ZU1 SYSTEM BLOCK DIAGRAM

PROJECT : ZU1
Quanta Computer Inc.

Size	Document Number	Rev
	CLK_GEN/CK505	3B
Date:	Tuesday, April 10, 2007	Sheet 2 of 39

PROJECT : ZU1 Quanta Computer Inc.	PROJECT : ZU1	APPROVE BY : James Lu	DRAWING BY:Barry Lee	Stage: A1	CHANGE LIST SHEET 1
	MB ASSY'S P/N : 31ZU1MB0000	PROJECT LEADER:Jack Wu	DOCUMENT NO:	DATE :2006/12/09

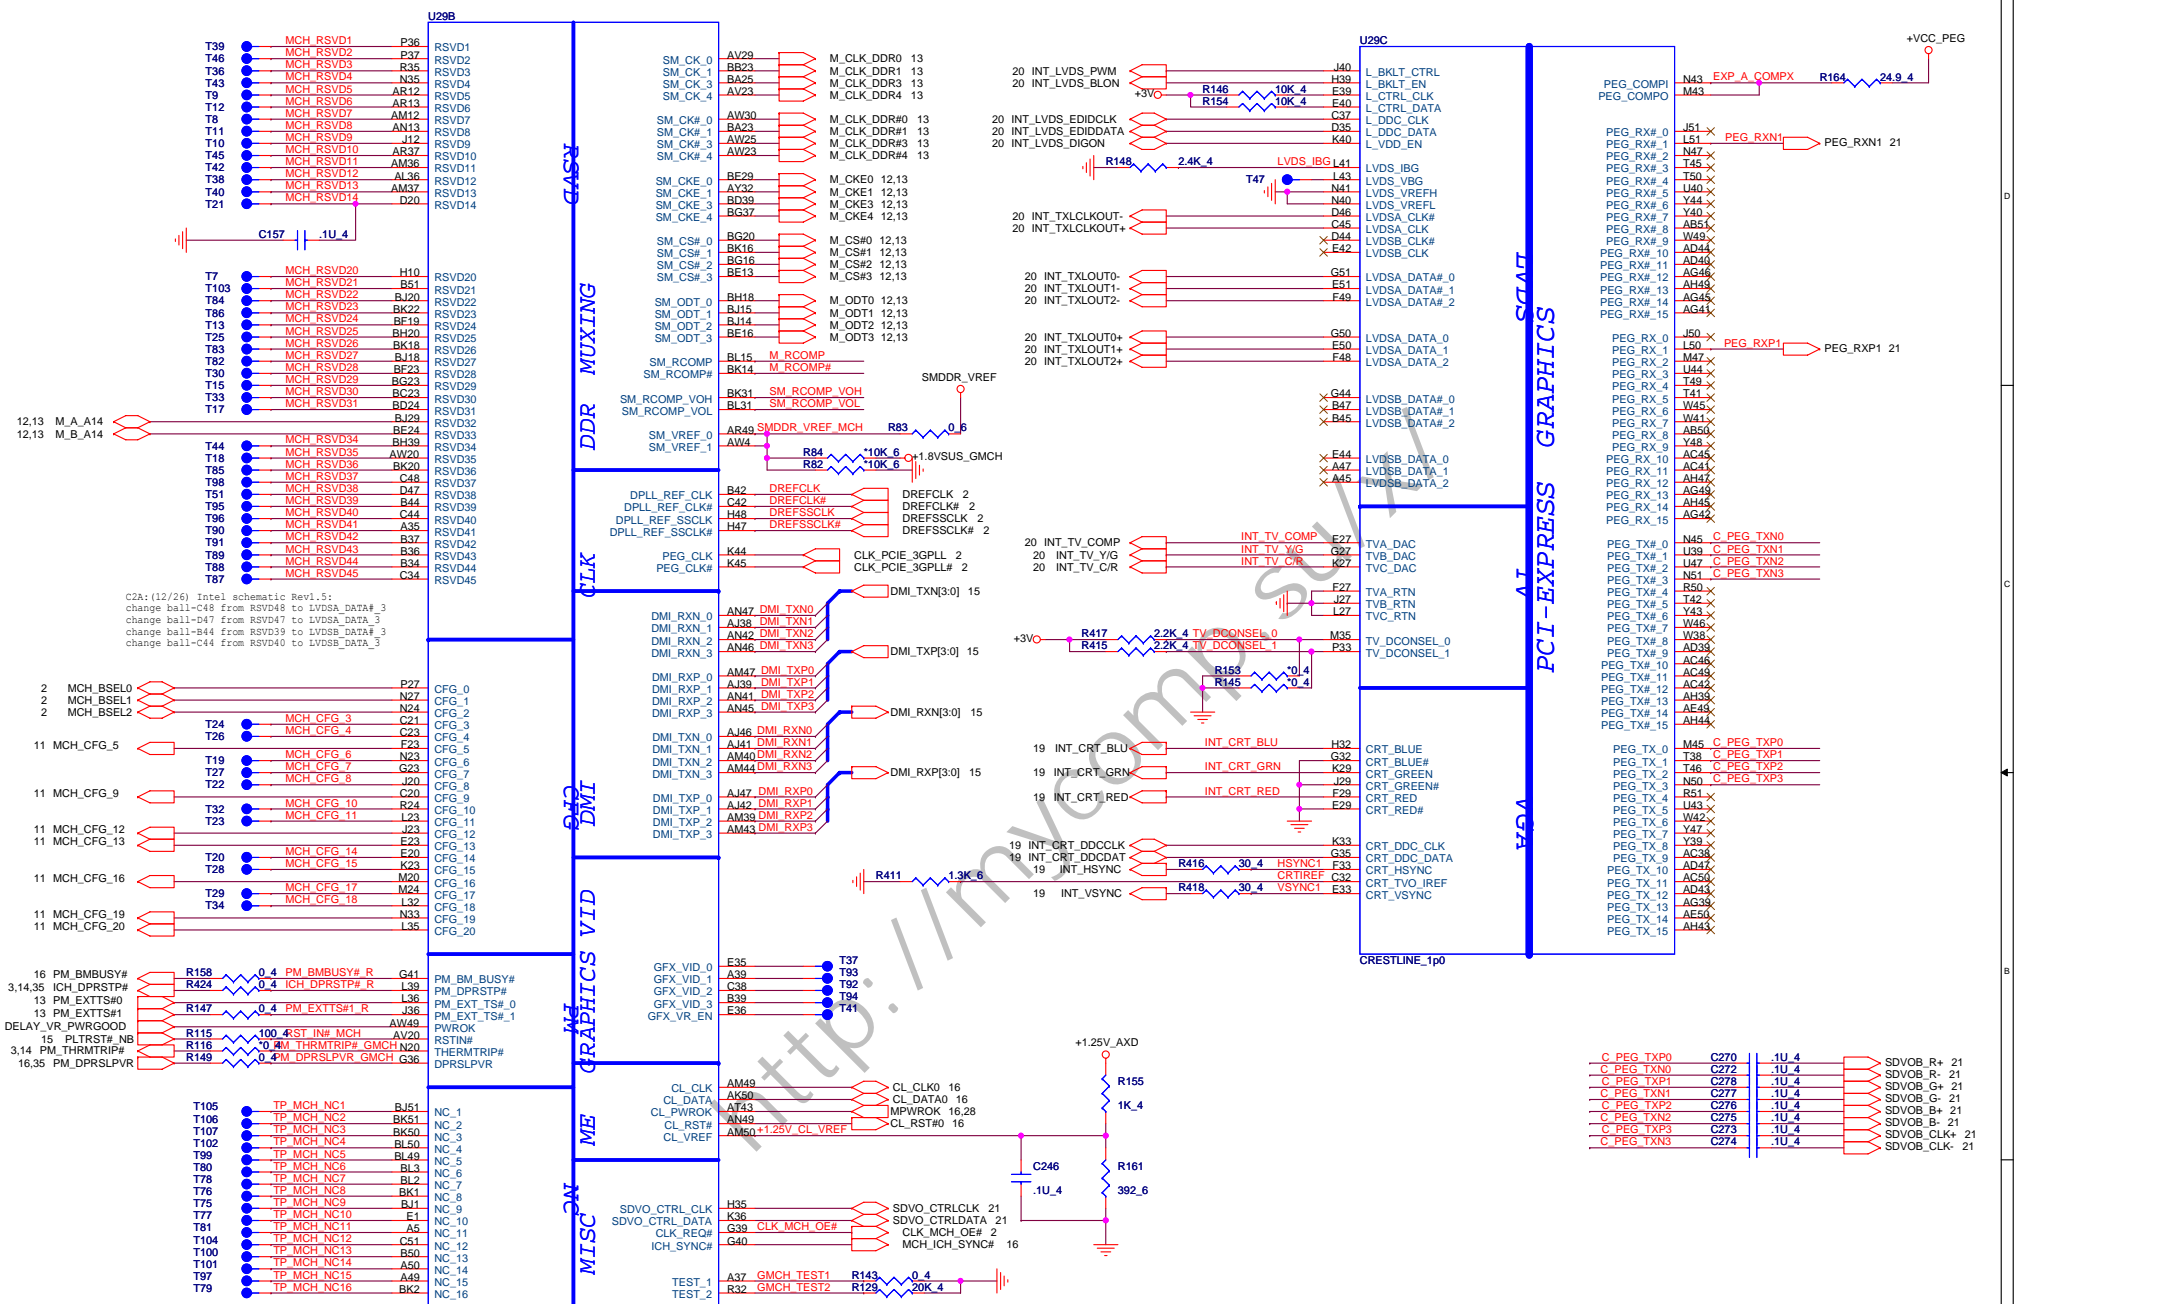
C2A: (12/26) Intel schematic Rev1.5:
 change ball-c48 from RSV48 to LVDSA_DATA#_3
 change ball-c47 from RSV47 to LVDSA_DATA_3
 change ball-b44 from RSV39 to LVDSB_DATA#_3
 change ball-c44 from RSV40 to LVDSB_DATA_3

Size	Document Number	Rev
	GMCH Power-1(4 of 7)	3B
Date:	Tuesday, April 10, 2007	Sheet 8 of 39

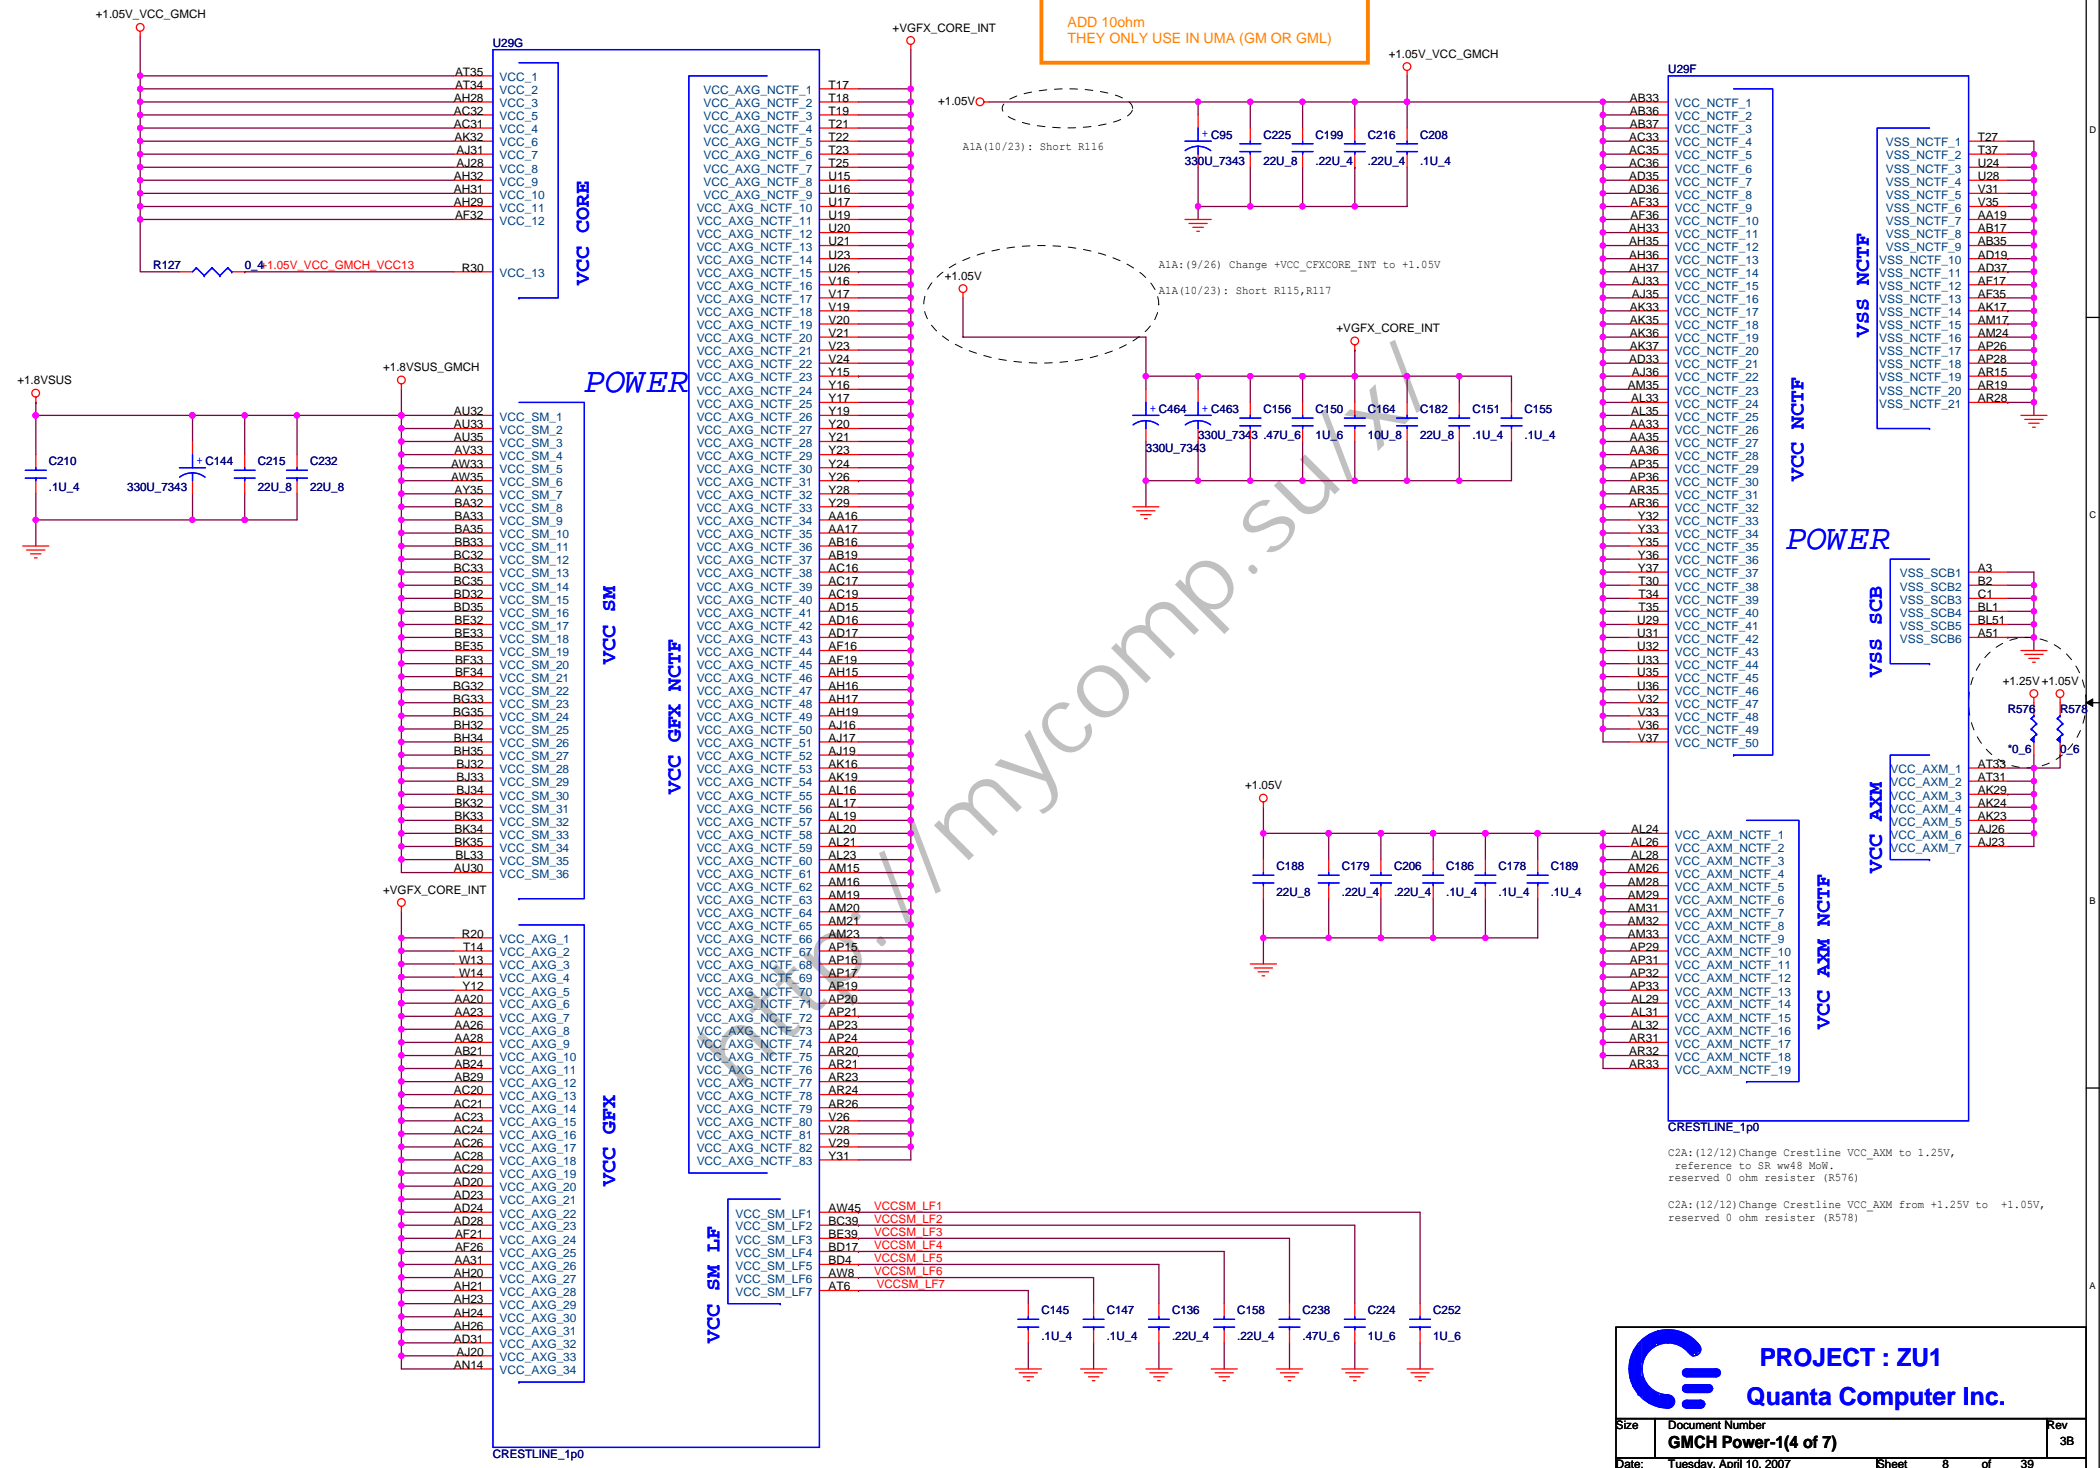
C2A: (12/12) Change Crestline VCC_AXM to 1.25V, reference to SR ww48 MoW, reserved 0 ohm resistor (R576)

C2A: (12/12) Change Crestline VCC_AXM from +1.25V to +1.05V, reserved 0 ohm resistor (R578)

Size	Document Number	Rev
	GMCH Power-2(5 of 7)	3B
Date:	Tuesday, April 10, 2007	Sheet 9 of 39

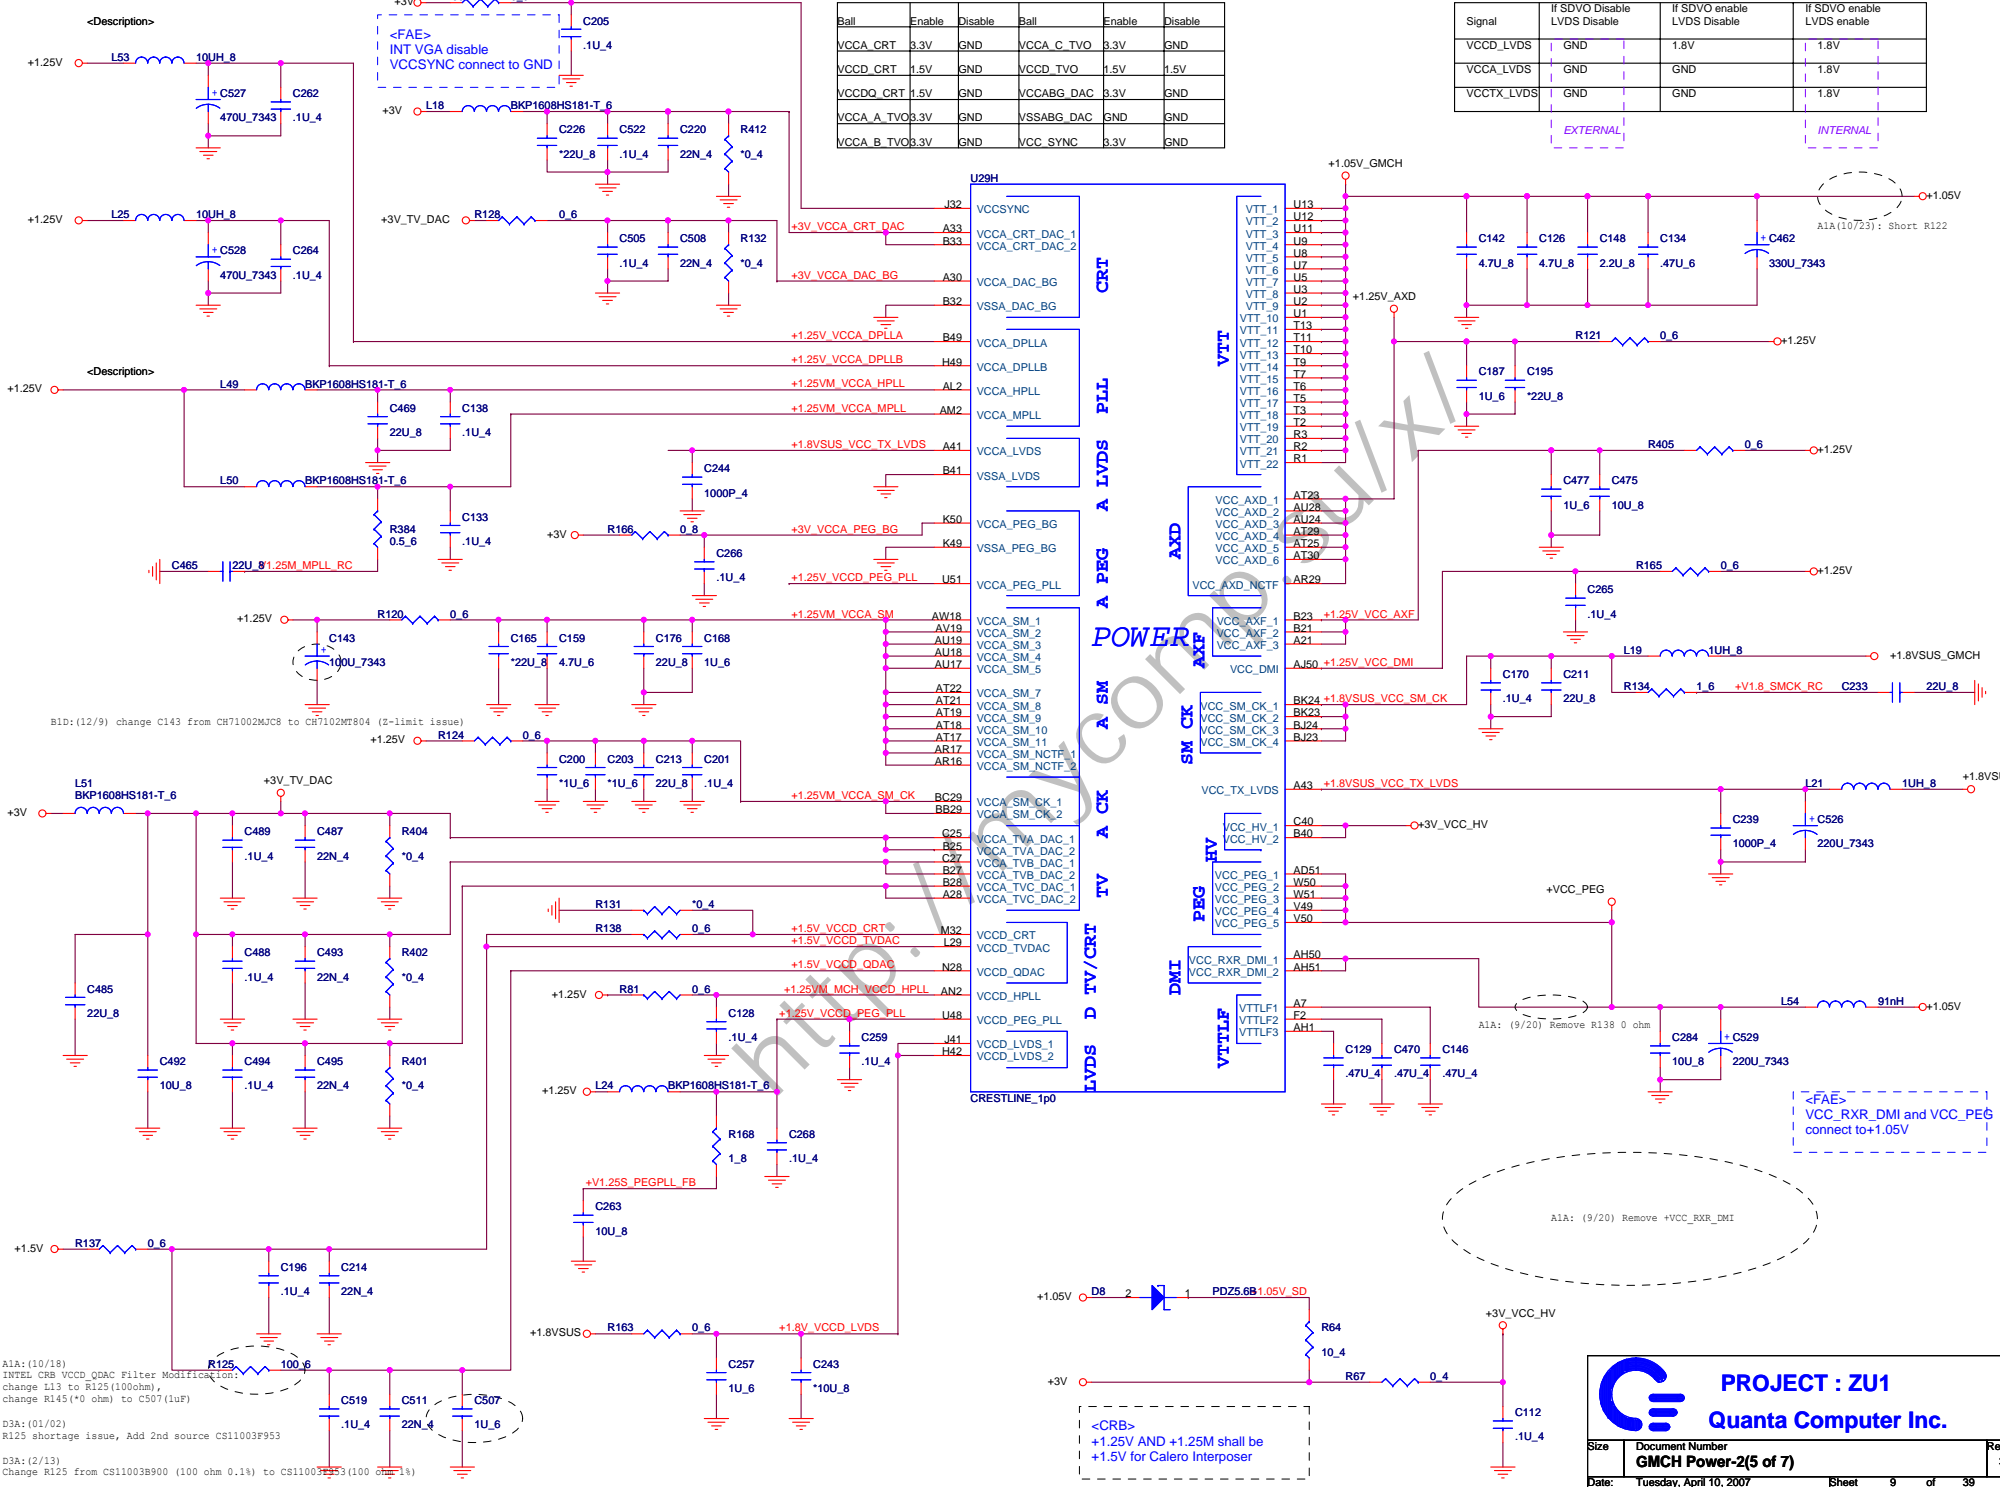
BID: (12/9) change C143 from CH71002MJC8 to CH7102MT804 (2-limit issue)

A1A: (10/18)
INTEL: CRB VCCD_QDAC Filter Modification, change L13 to R125(100ohm), change R145(*0 ohm) to C507(1uF)
D3A: (01/02)
R125 shortage issue, Add 2nd source CS11003F953
D3A: (2/13)
Change R125 from CS11003B900 (100 ohm 0.1%) to CS11003F953 (100 ohm 1%)

Size: Document Number: **GigaLAN (BCM5787M) / RJ45** Rev: **36**

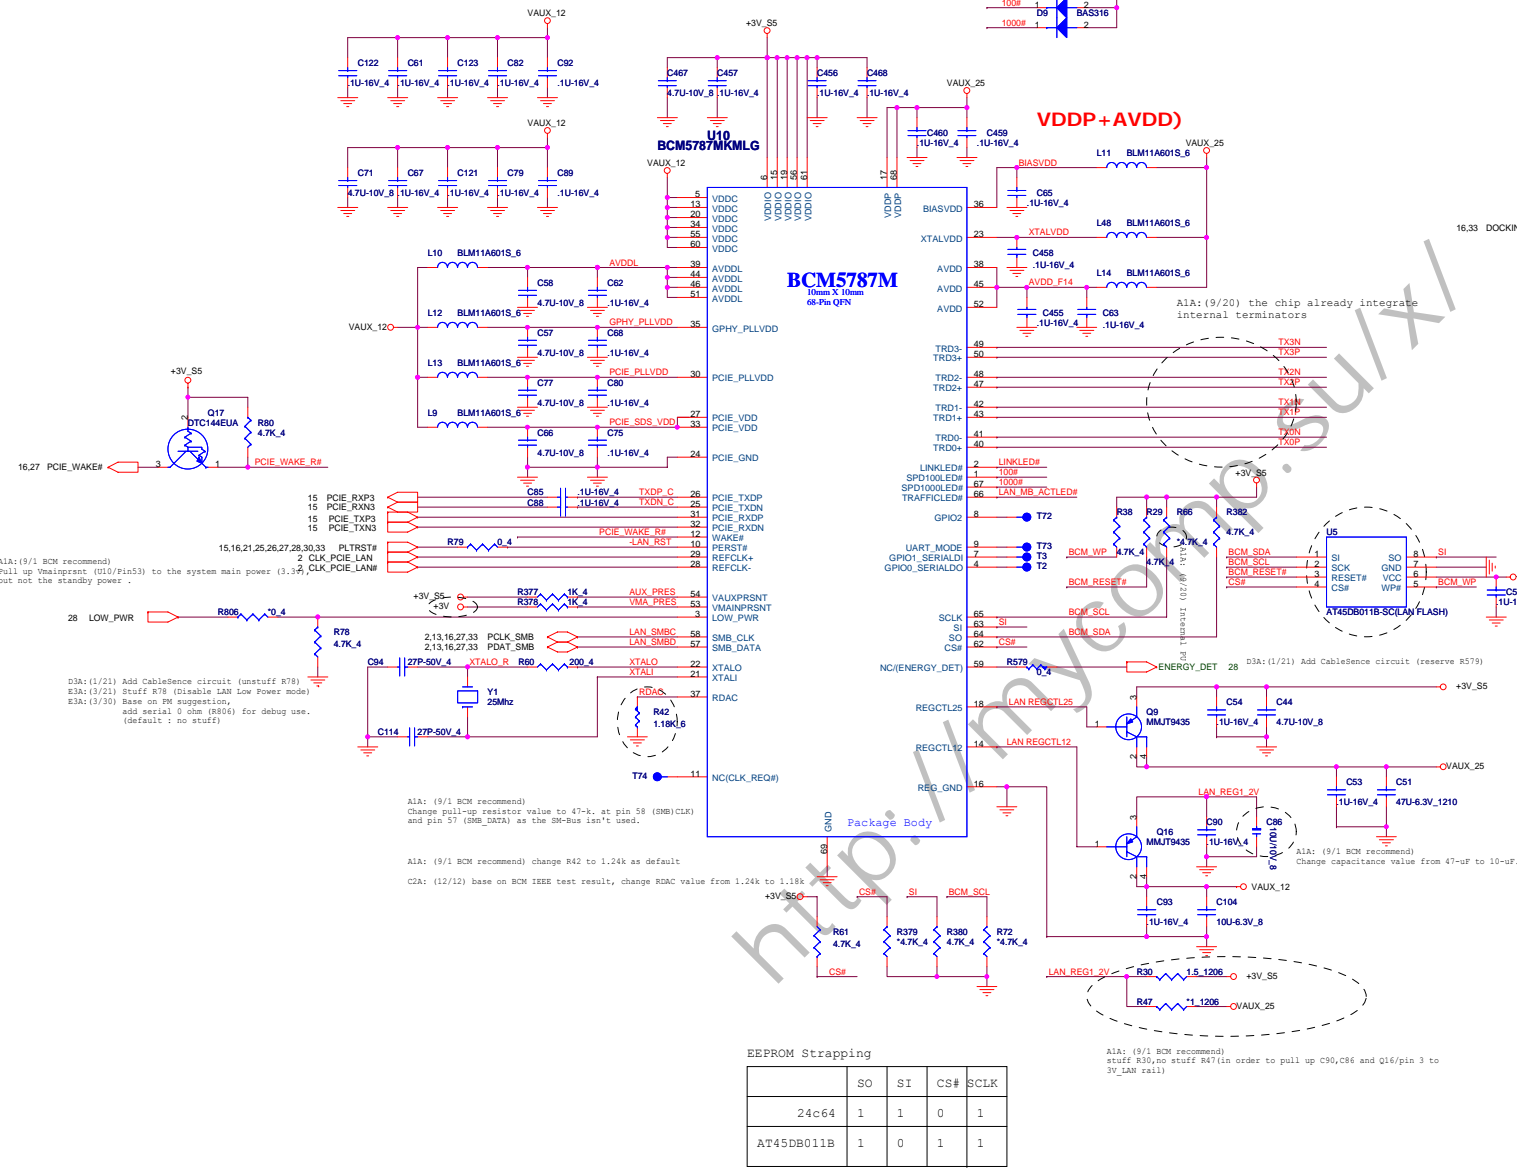
A1A: (9/27) Change +3V_LAN_S5 to +3V_S5

A1A: (9/1 BCM recommend)
Pull up Vmainprst (U10/pin53) to the system main power (+3V_S5) but not the standby power.

D3A: (1/21) Add cable sense circuit (unstuff R78)
E3A: (1/21) Stuff R78 (Disable LAN Low Power mode)
E3A: (1/30) Base on PM suggestion, add serial 0 ohm (R806) for debug use. (default: no stuff)

D3A: (1/21) Add cable sense circuit (unstuff R78)

A1A: (9/1 BCM recommend)
Change pull-up resistor value to 47k, at pin 58 (SMB_CLK) and pin 57 (SMB_DATA) as the SN-Bus isn't used.

A1A: (9/1 BCM recommend) change R42 to 1.24k as default

C2A: (12/12) base on BCM IEEE test result, change R42C value from 1.24k to 1.18k

A1A: (9/1 BCM recommend)
stuff R30, no stuff R47 (in order to pull up C90, C86 and Q16/pin 3 to 3V_LAN rail)
